Notice of Allowability

10/791,976

EXAMINER'S AMENDMENT

Diana Lynne Gann et al. Serial No. 10/791,976
"Tampon Applicator Having a Rupturable Membranous
Cap"

Fig. 1a

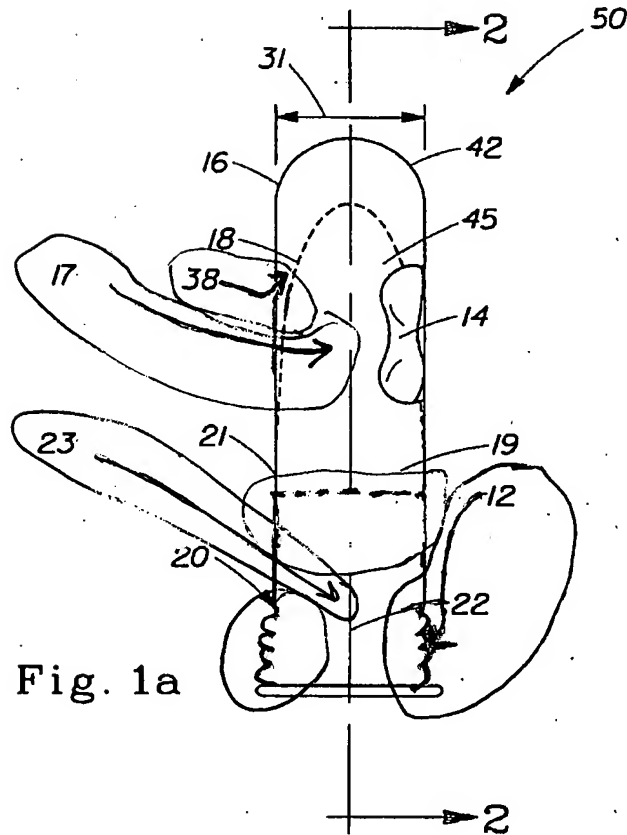
on page 3, line 22: change "cut out...axis" to --cross section view of the tampon holder tube along line 2-2 of Figure 1a in combination with a plunger--;

Fig. 6

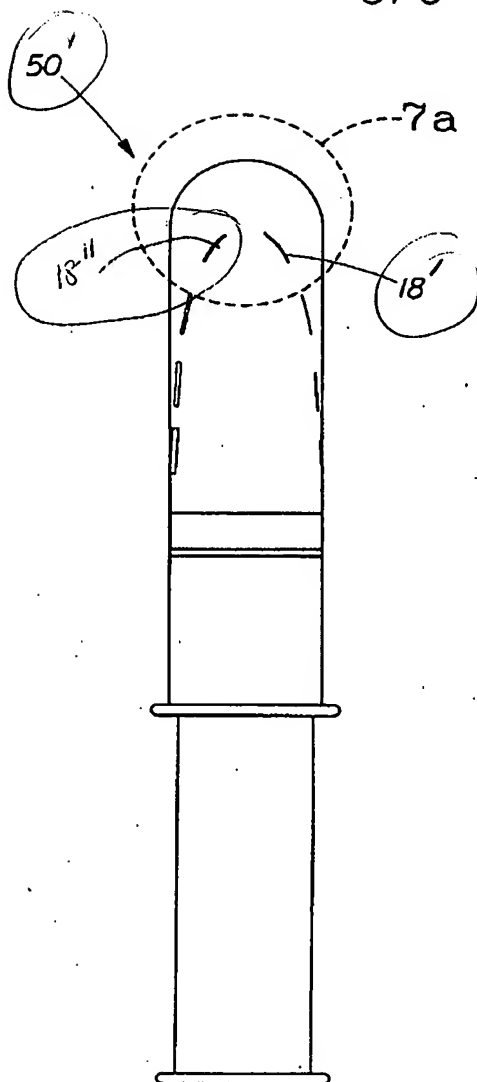
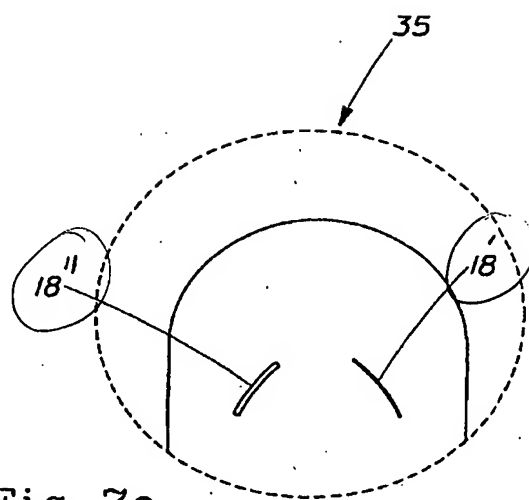
Figure 6 is an alternative embodiment of a feminine hygiene product 50'. The regions of rupture [[18]] 18', 18'' are shown. Figure 7a is a partial view 35 of Figure 6 showing the regions of rupture [[18]] 18', 18''. Figure 7b is an alternative embodiment of [[the]] a feminine hygiene product 50''. The regions of rupture 18''' are shown. Also, the plunger 13 is shown. Figure 7c shows an alternative embodiment of feminine hygiene product 50''' partially-expelling tampon

Fig. 7b

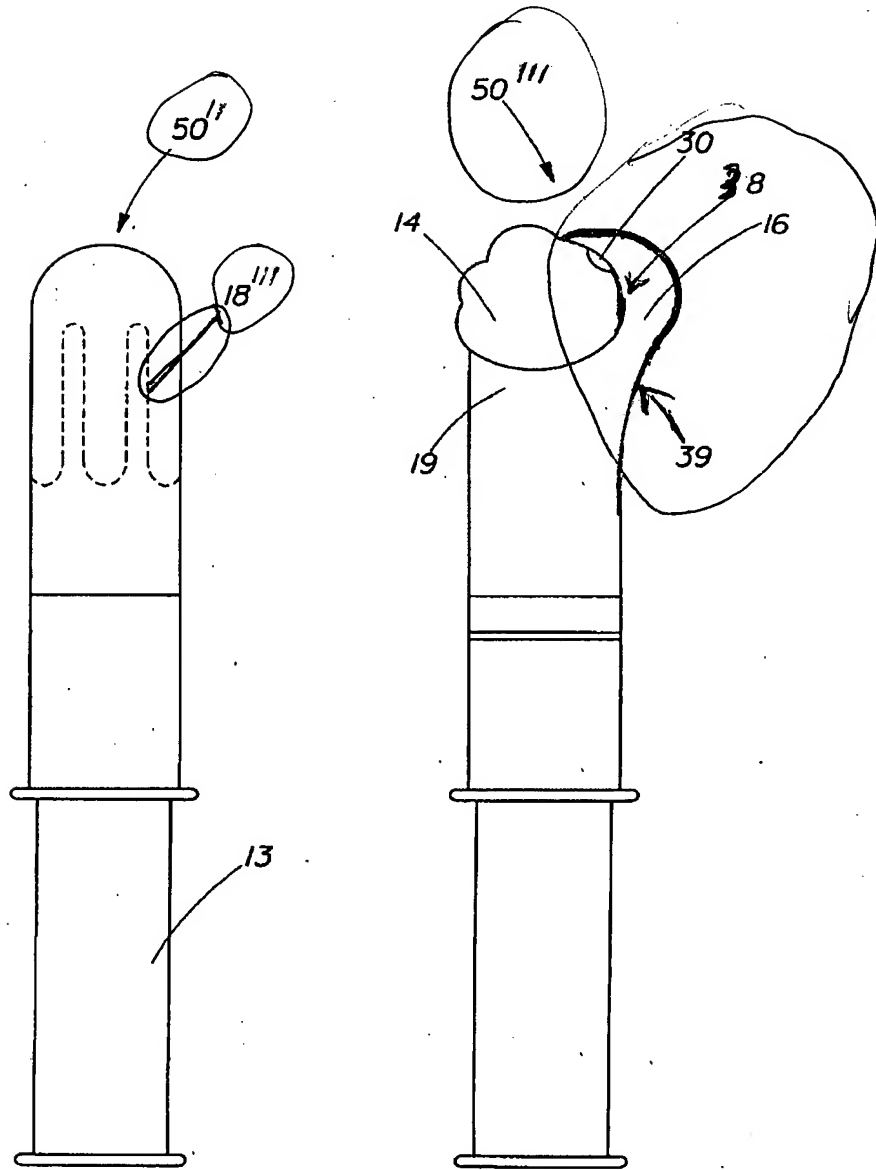
14. A portion of the feminine hygiene product 50''' comprises a rupturable membranous cap 16 comprising a projection[[s]] 30 and a hinge 39. The regions of rupture 18 [[may]] allowed a portion of the rupturable membranous cap 16 and a portion of the tampon holder tube 19 to separate.
